Determination 2010/081

Refusal to issue a code compliance certificate for a 7-year-old house with a solid wall system at 1/28 Ireland Road, Panmure, Auckland

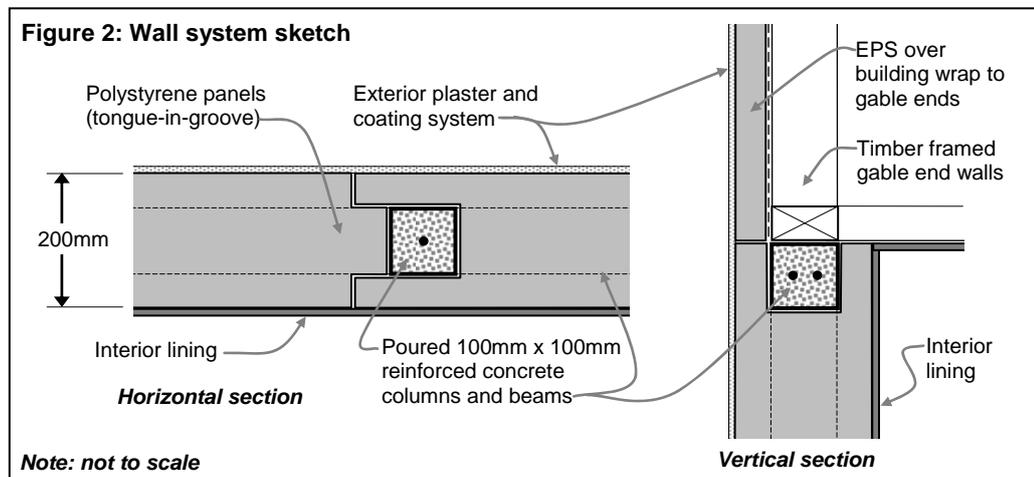
3.3.1 The exterior walls are a proprietary solid wall system, as shown in Figure 2.

3.3.2 The main walls of the house are constructed from 200mm thick interlocking polystyrene (“EPS”) panels, which provide formwork for a reinforced concrete post and beam structure. Steel reinforcing rods connect the poured columns and beams to the foundations, the first floor framing and the roof framing. At joinery openings, timber sub-frames fit within the panel grooves, with planted solid timber packers against which the windows and door are face-fixed.

3.3.3 The gable ends are relatively small areas, timber-framed and clad in a form of monolithic cladding system known as EIFS⁵. In these areas, the proprietary cladding system consists of 90mm polystyrene backing sheets fixed directly to the framing over the building wrap. The recessed timber-framed walls to the small upper deck are clad in fibre-cement sheet fixed directly to the framing over the building wrap.

3.3.4 At the base of the solid walls, a plastered polystyrene band with a sloped top is installed over the junction with the foundation wall. A similar band covers the inter-storey junction. A 3mm mesh-reinforced plaster system is applied as a continuous coating to the exterior of the solid walls, the polystyrene bands, the EIFS backing sheets and the fibre-cement backing sheets.
